3.0 CORRECTIONS AND ADDITIONS TO THE DRAFT EIR

1. ALTERNATIVE 5: MODIFIED PLANNING AREA 1 ONLY ALTERNATIVE

Cielo Vista Project

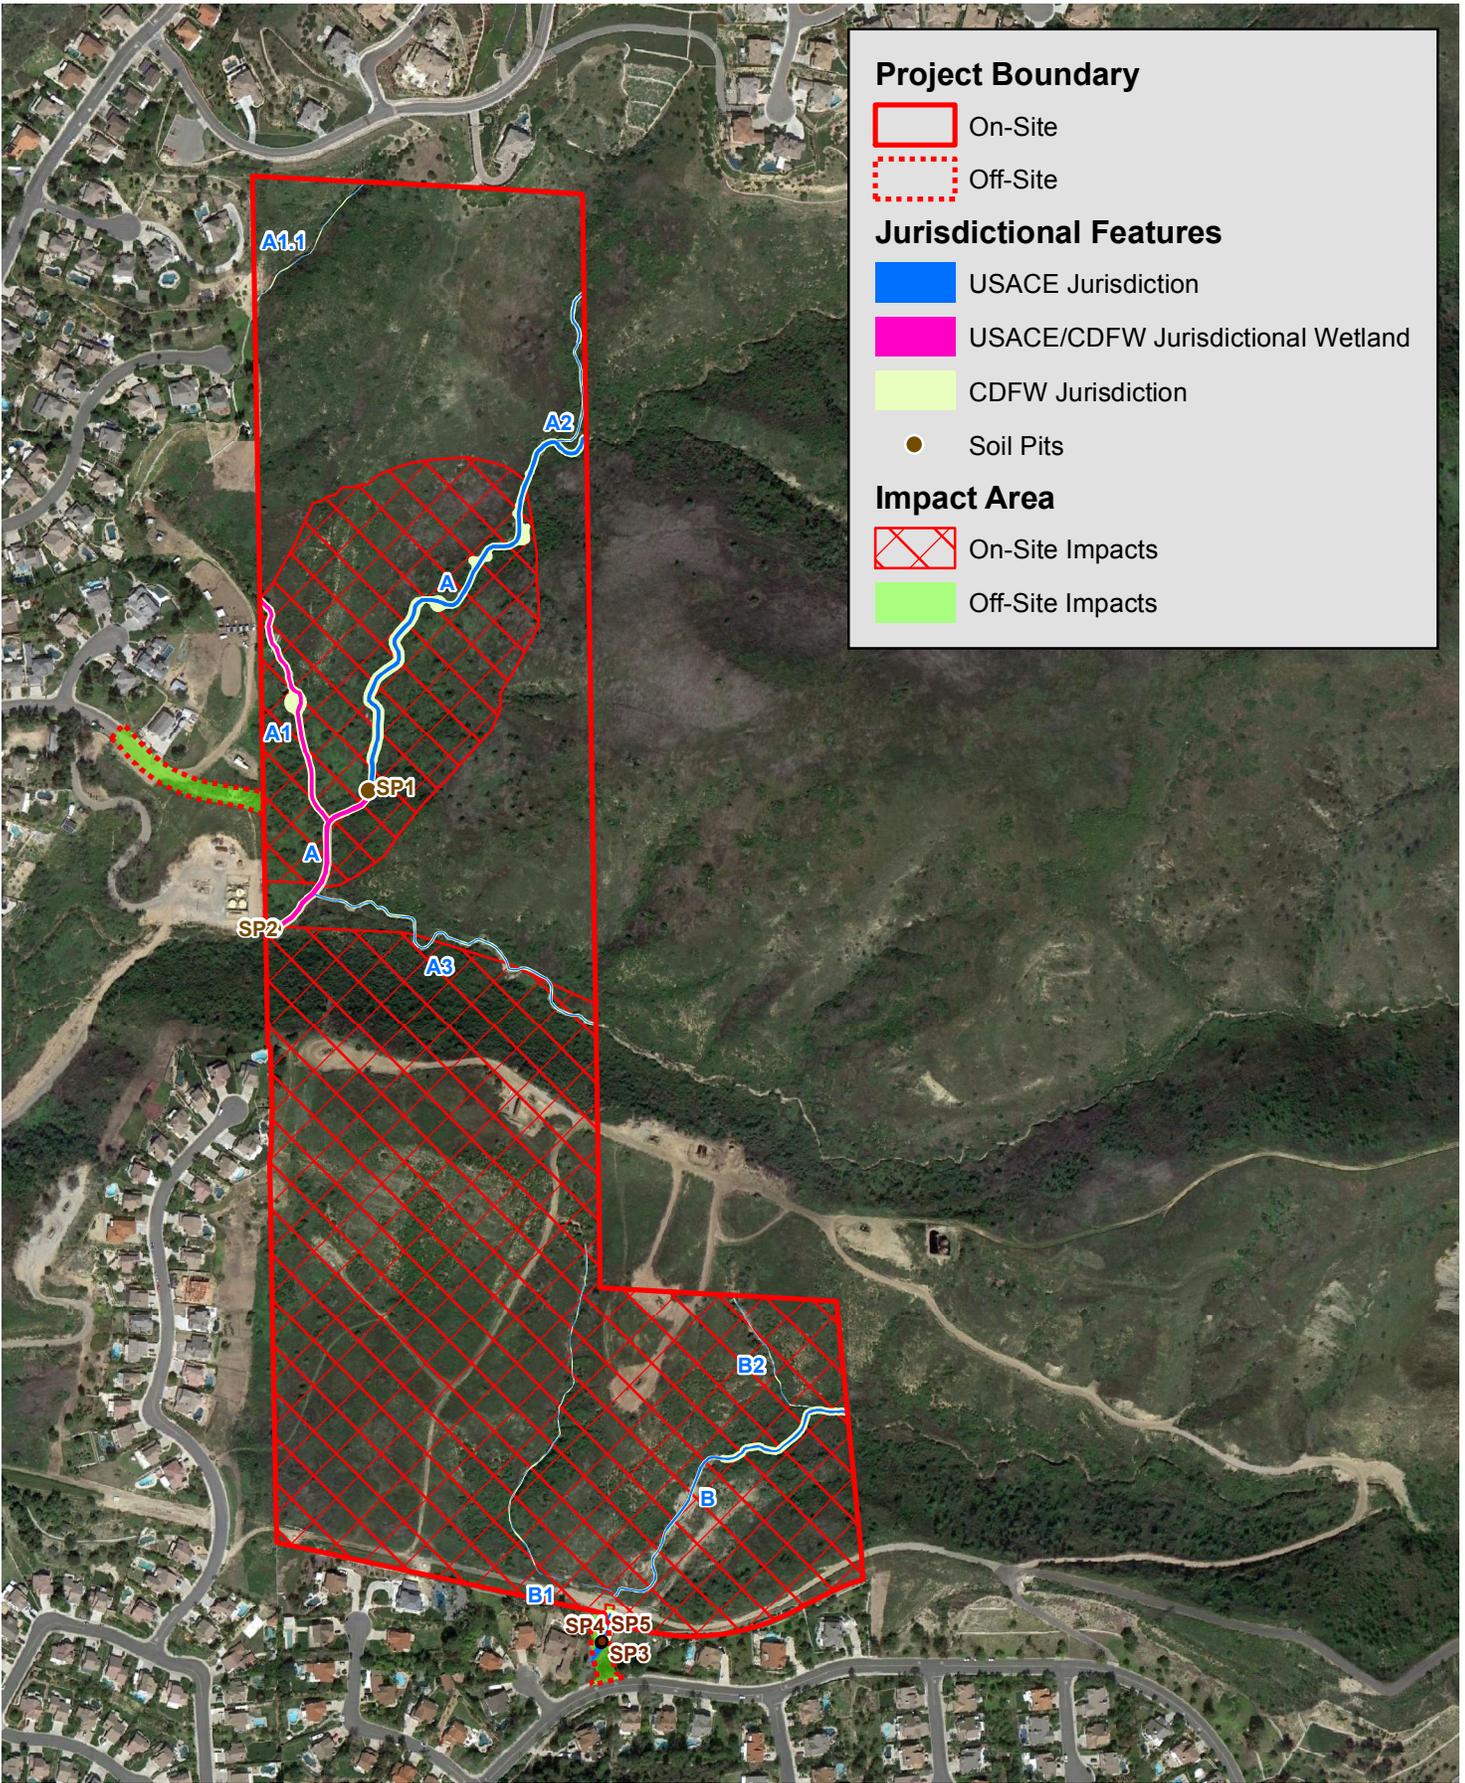
9. **Page 4.3-38. Revise Figure 4.3-8 to correctly illustrate Drainage B near southern project site boundary:**

See revised Figure 4.3-8 on page 3-107.

FIGURE
4.8-2a

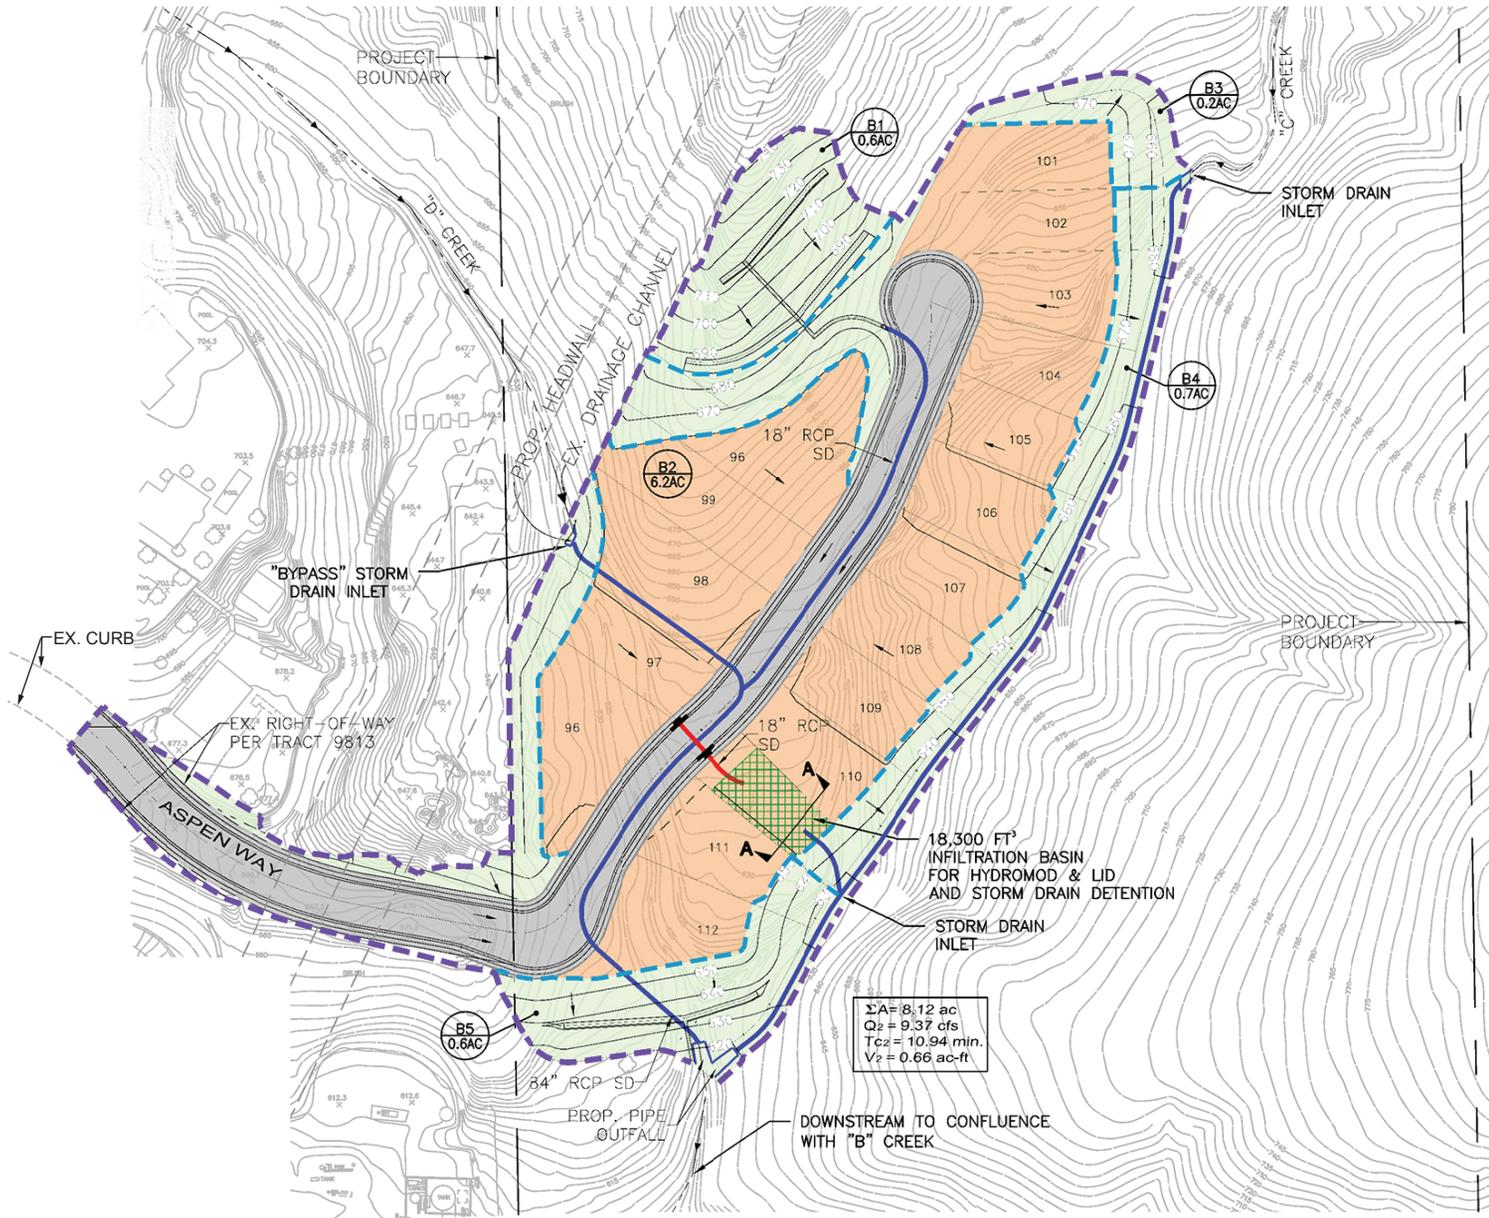
7. **Pages 4.8-17 and 4.818. Modify the list of Infiltration, Biotreatment, Hydromodification and Treatment Control BMPs with the following changes. Page 4.8-17 also references Figure 4.8-2, *Project Drainage-BMP Plan*. Figure 4.8-2 is shown page 4.8-19 of the Draft EIR. Figure 4.8-2 has been updated to show the Project’s current proposed BMPs. See Figure 4.8-2(a-b) on the following pages.**

Noise Measurement Locations

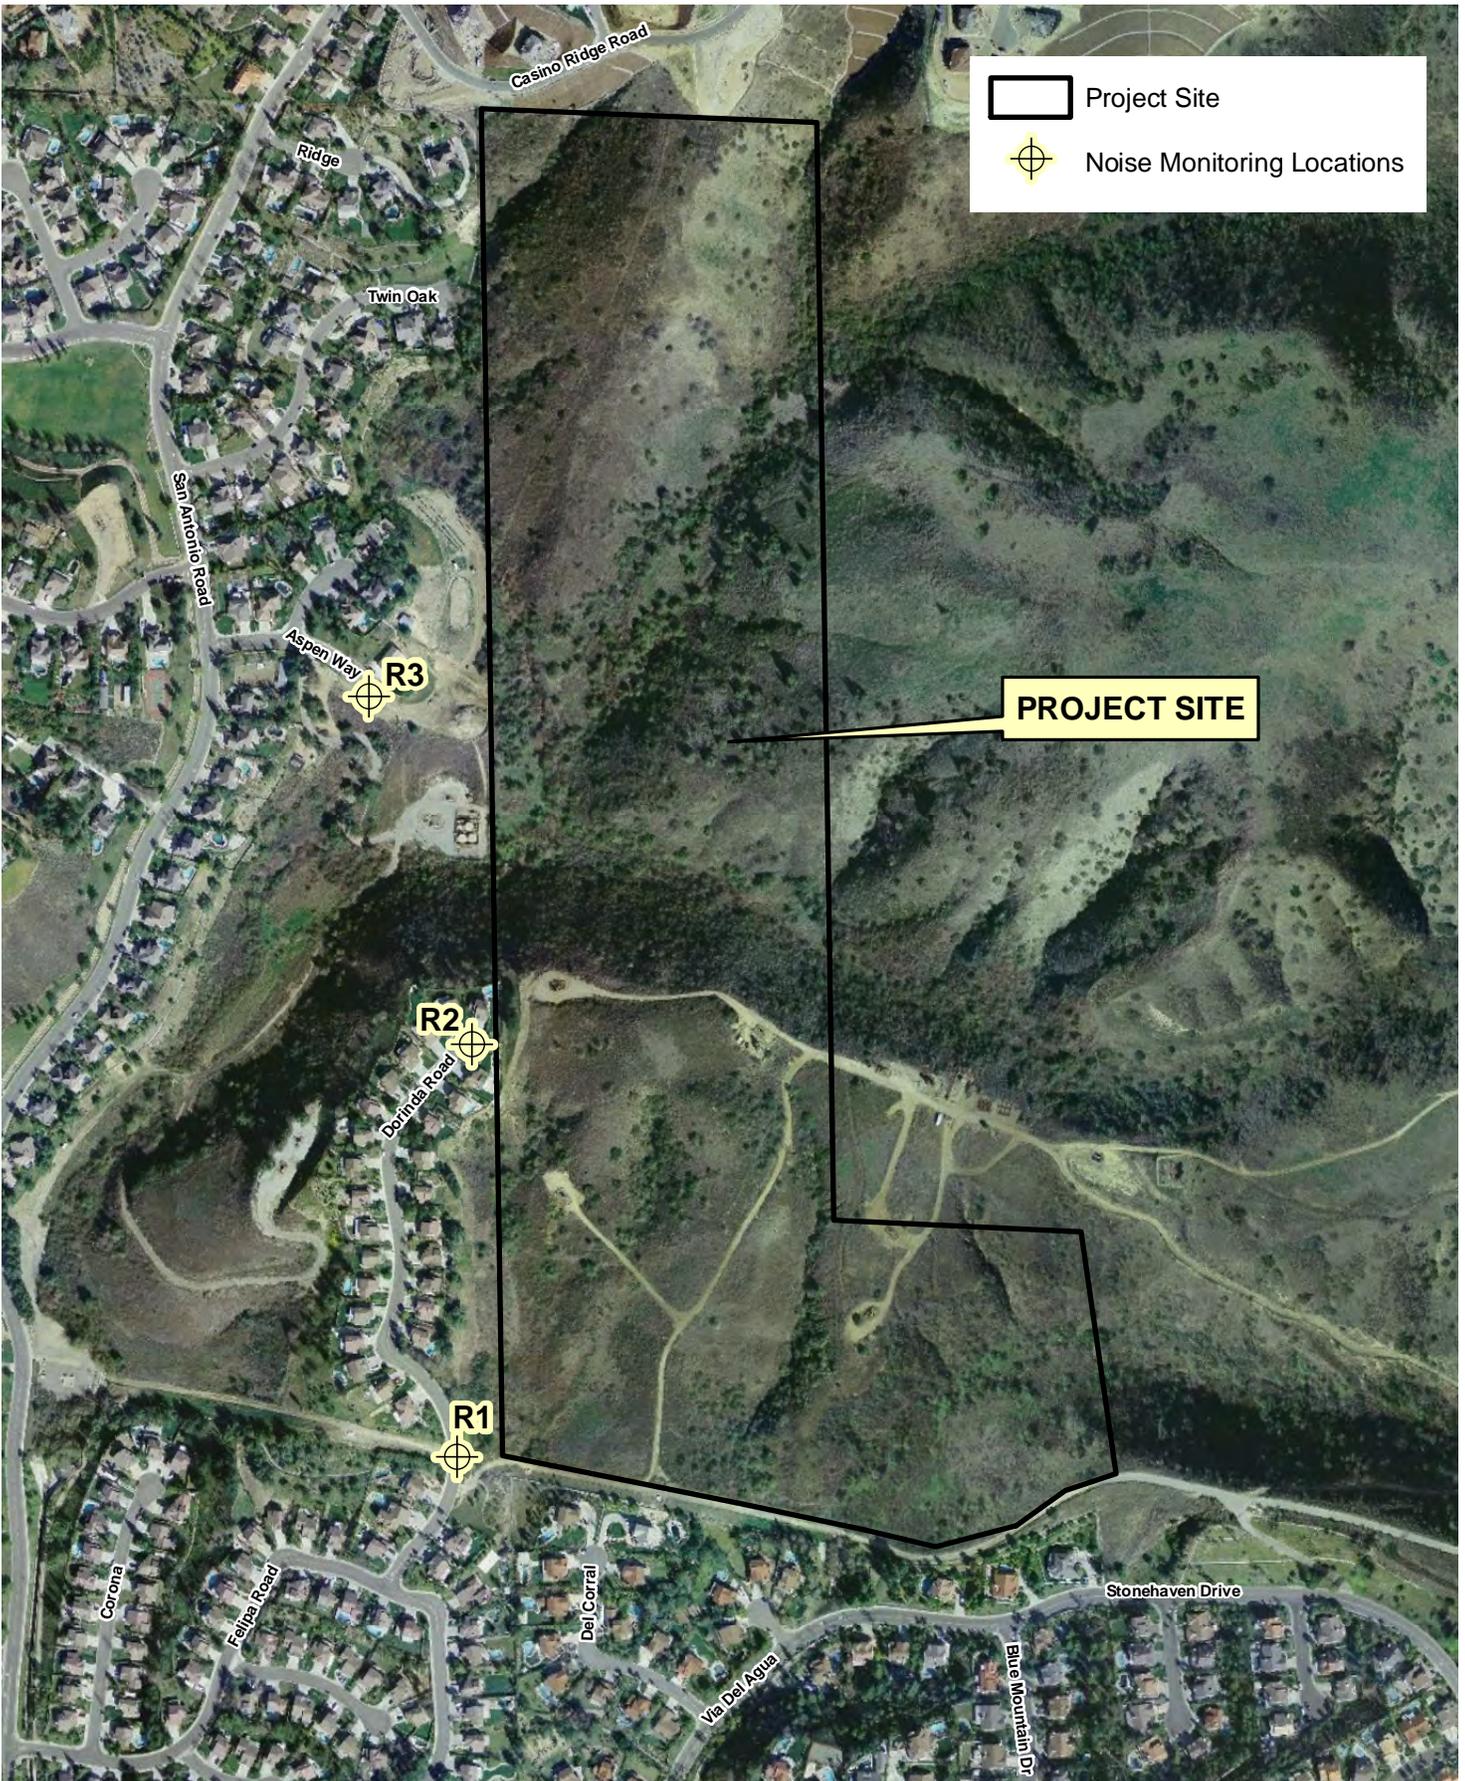
As shown in in **Figure 4.10-2, Noise Measurement Locations**, long-term (24-hour) measurements were conducted at one location, identified as R1 to quantify the existing noise environment. Short-term (15-minute) measurements were recorded at two additional locations, identified as R2 and R3. The long-term ambient noise measurements at locations R1 were conducted from Wednesday, June 25, through Thursday, June 26, 2014. The short-term noise measurements at locations R2 and R3 were conducted on June 25, 2014 between the hours of 7:00 A.M. and 9:00 A.M. Descriptions of the noise measurement locations are provided below:

EXHIBIT 3-12
**EXISTING (2012)
 PEAK HOUR INTERSECTION LOS**

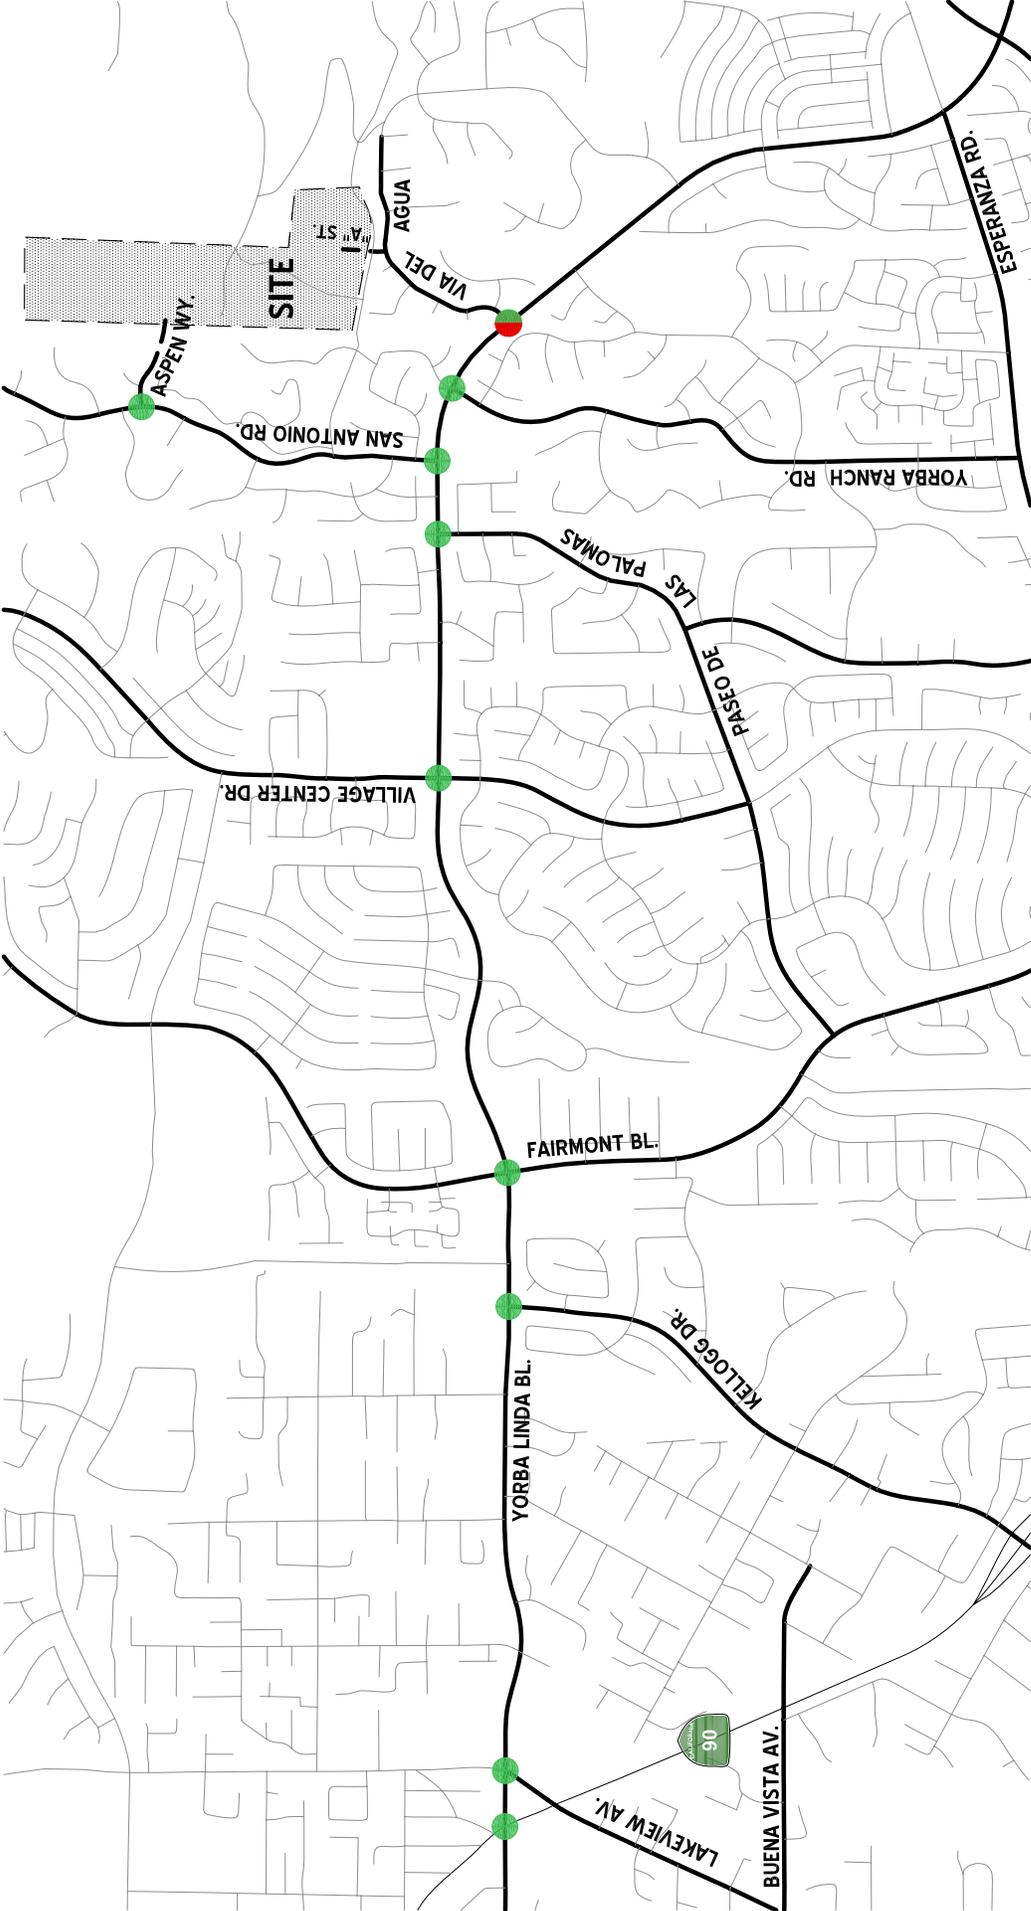
3. Page 35. Modify Figure 3-12 with the following changes:

Exhibit 3-12 has been corrected to maintain consistency with the intersection operational analysis provided in Table 3-1. The Exhibit has been revised to reflect acceptable peak hour operations during the PM peak hour. The revised Exhibit is shown below.
